City of West Linn
PRE-APPLICATION CONFERENCE MEETING
Notes
March 21, 2013

SUBJECT: Eleven lot “Sunbreak” subdivision at 23150 Bland Circle with possible Class II Variances for lots that do not meet the dimensional standards of the R-7 zone (the “two and a half times rule”) and blocks in excess of 800 feet.

SUNBREAK SUBDIVISION

Figure 3: 25% slope indicated by grey areas above

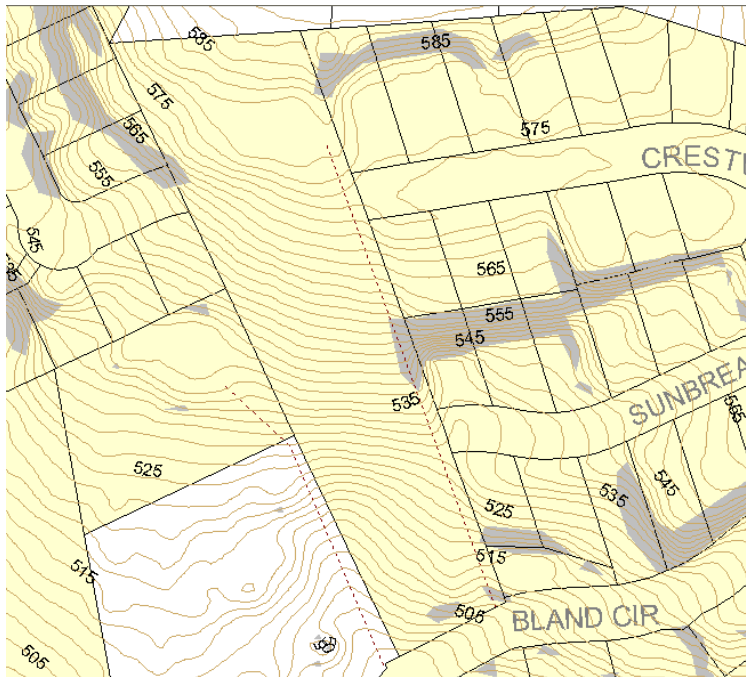
The land rises 82 feet from Bland Circle's elevation of 505 feet to the north end of the property where the elevation is 587 feet. The slope of the hillside is fairly constant averaging 14 percent although the northernmost 150 feet, where the house and parking

are located, has a more modest slope of 0-5 percent. There are some small isolated slopes over 25 percent; most notably along the existing gravel driveway. However, these 25 percent sloped areas are not extensive enough to trigger a PUD. (It would require over 25 percent of the site to be sloped over 25 percent before a PUD is required.)

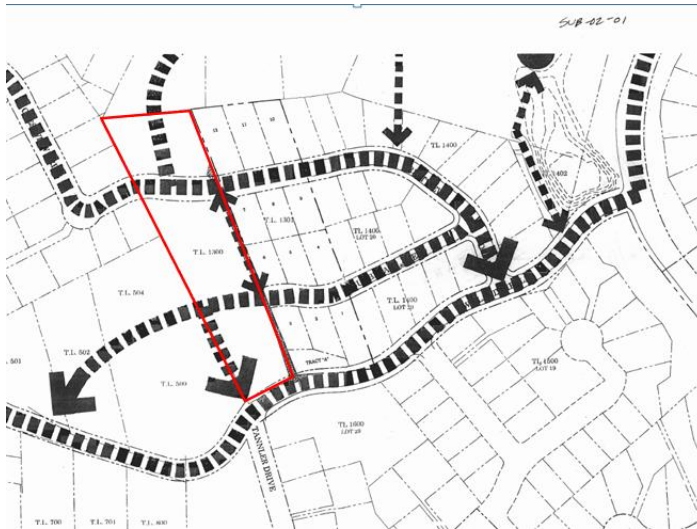
"Florendo's Hideaway" subdivision stubs Crestview Drive and Sunbreak Lane into the subject property. The expectation is that these streets will extend across this property and connect with the properties to the west. The connection of Crestview Drive is fairly obvious since that street's namesake is already built and stubbed out in Ridge View Estates Phase II to the west. Unfortunately, it is unlikely that two oak trees in the Crestview Drive alignment can be "designed around" since the grades in that area will need to be dropped significantly to connect with Ridge View Estates II.

Proposed alignment submitted as part of Fernando's Hideaway 2002 application

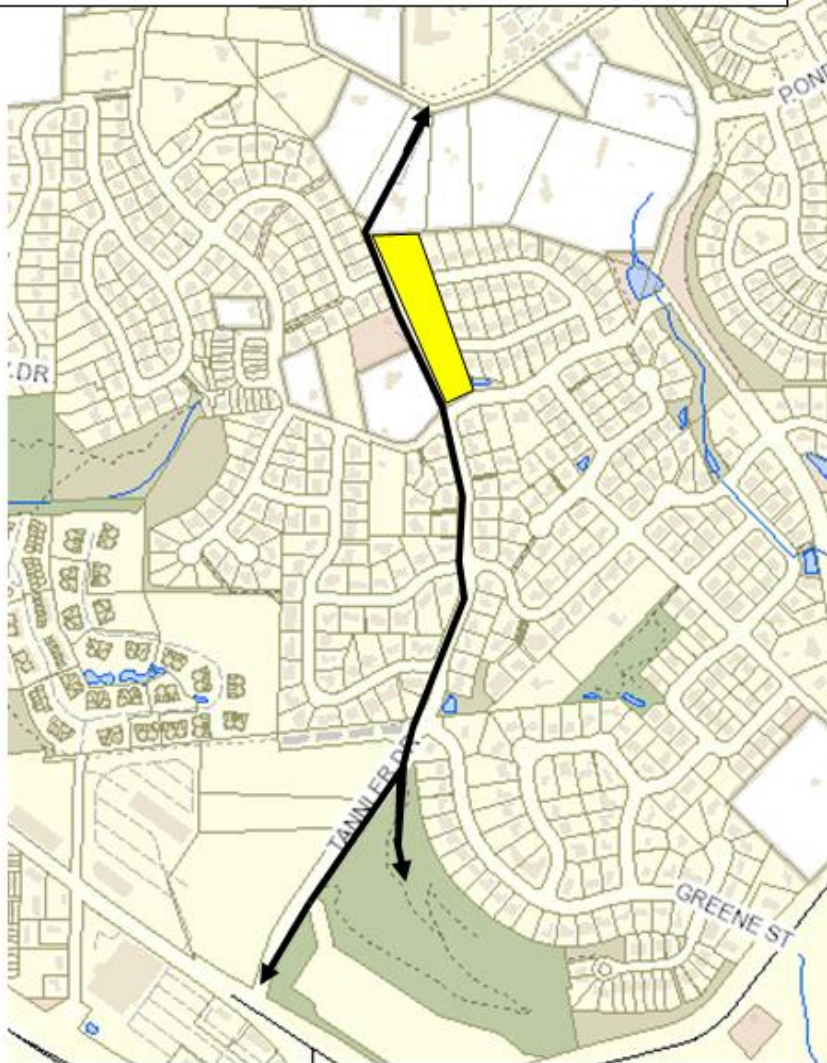
For Sunbreak Lane, the connection is challenging since the portion of the property that it would connect with (tax lot 500) is occupied by a large, attractive contemporary house. The applicant's initial proposed alignment would go right into that house. A more appropriate road alignment (and one that the applicant subsequently agreed to in principle) would angle southwards along the common lot line to connect Sunbreak Lane with Bland Circle at the Tannler Drive intersection. This alignment (See illustration of

street below) is consistent with the plan submitted when Florendo's Hideaway was applied for in 2002.

The applicant agreed to the concept of a shared street improvement to include ROW dedication, six foot wide sidewalk, six foot wide planter curb/gutter and 20 feet of street width with the expectation that the owner of tax lot 500 will complete the remaining street section when that property is developed. The use of a sidewalk easement on lot 2 would be supported by staff so as to minimize the impact on lot size. A hammerhead feature was also proposed to facilitate turn movements and provide access to lot 3.

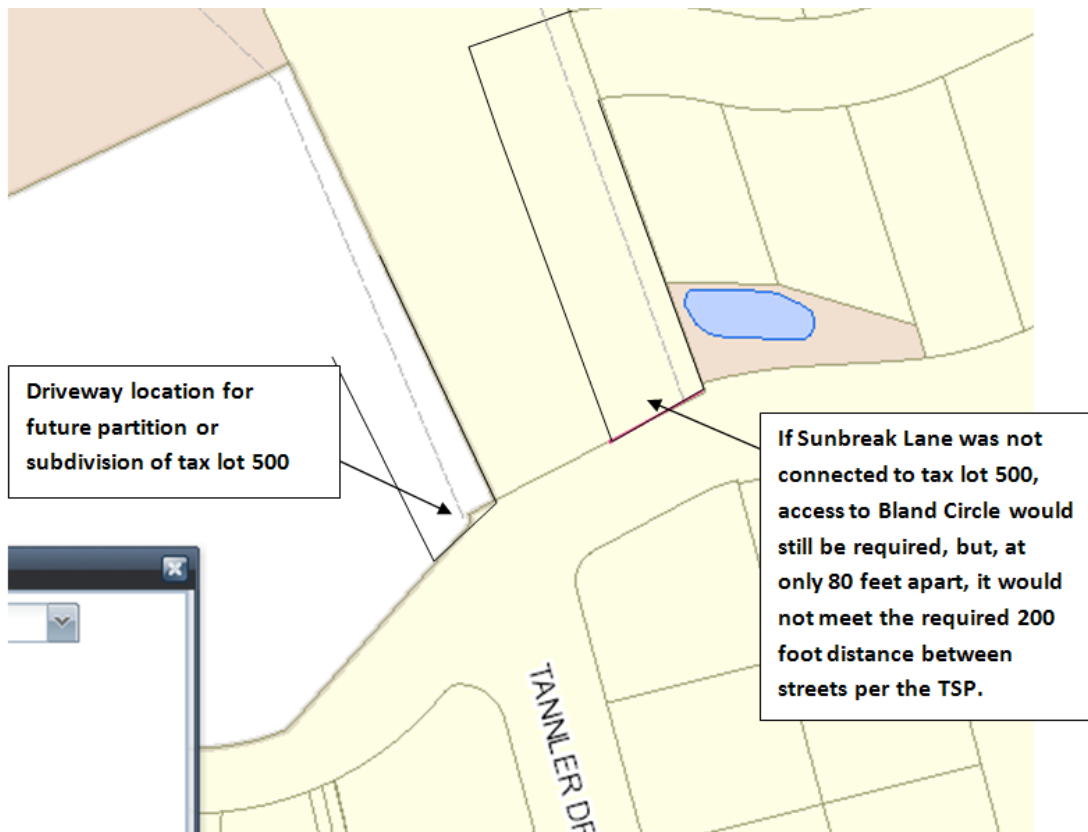
Regarding block length, staff notes that there is a maximum length of blocks of 800 feet in 85.200(B). Crestview Drive will be 1,849 feet in length. Sunbreak Lane will be 861 feet long. The applicant should be able to respond to the following code language:

It can be shown that Crestview Drive “justifies a variation” from 85.200(B) (2) given the layout of adjacent streets and the TSP separation requirements illustrated below.

Tannler Drive and Bland Circle intersection

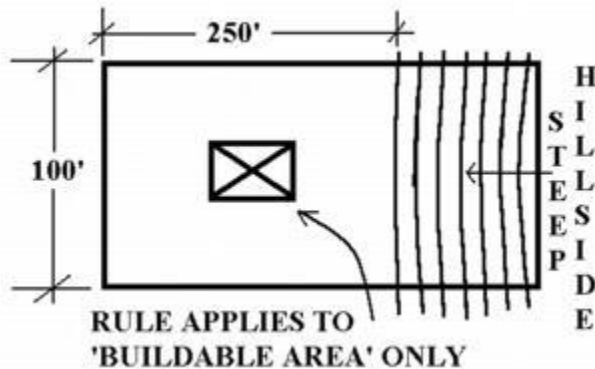
Subsection 48.025(B) (6) requires access driveways to meet the standards in Chapter 8 of the Transportation System Plan (TSP). Specifically, it states, “The access spacing standards found in Chapter 8 of the adopted Transportation System Plan (TSP) shall be applicable to all *newly established* public street intersections, private drives, and non-traversable medians.” (staff’s emphasis) If a public street is proposed using the existing alignment of the driveway accessing tax lot 500 and the pump station (lining up with the Bland Circle and Tannler Drive intersection) it would not be a newly established private drive, and therefore the TSP Chapter 8 standards would not be applicable. From that intersection to the nearest access driveway (Falcon Place) on the north side of Bland Circle is 440 feet so the access separation standards of 150 feet for driveways are met. The nearest public intersection is 1200 feet away so the access separation and 200 feet for public intersections is also met.

If the applicant connected Sunbreak Lane to Bland Circle using the existing gravel driveway alignment on the east side of the property it would violate the 200 foot intersection spacing requirements of the TSP with only 80 feet to the Tannler intersection. (See illustration on page 11.)

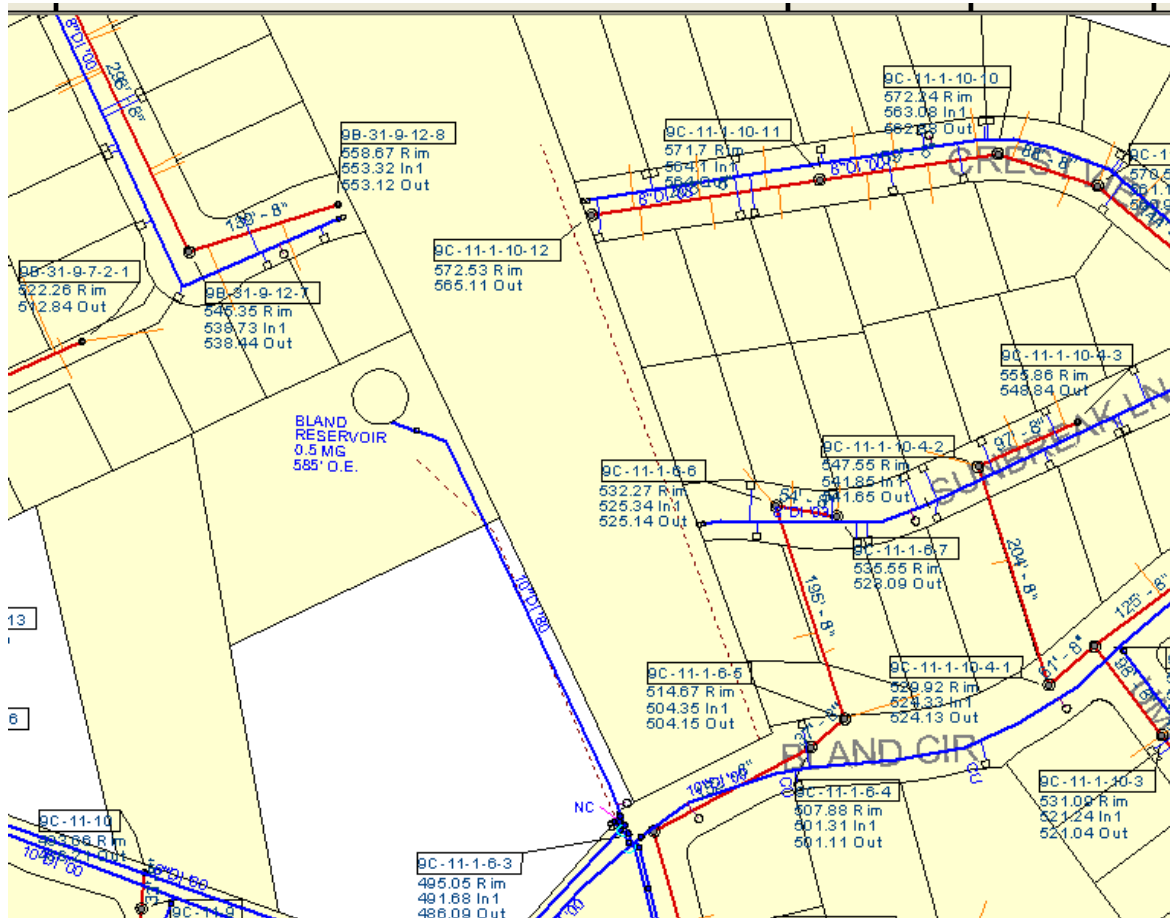
Lots 3, 7, 8 and 11 are too long (staff measured the width at right angles to the side lot lines and lot depth at the midpoint (see diagram below)). These lots need to be re-designed per code or Class II variances need to be requested. Staff can support the variances given the location of the streets and the shape of the property.
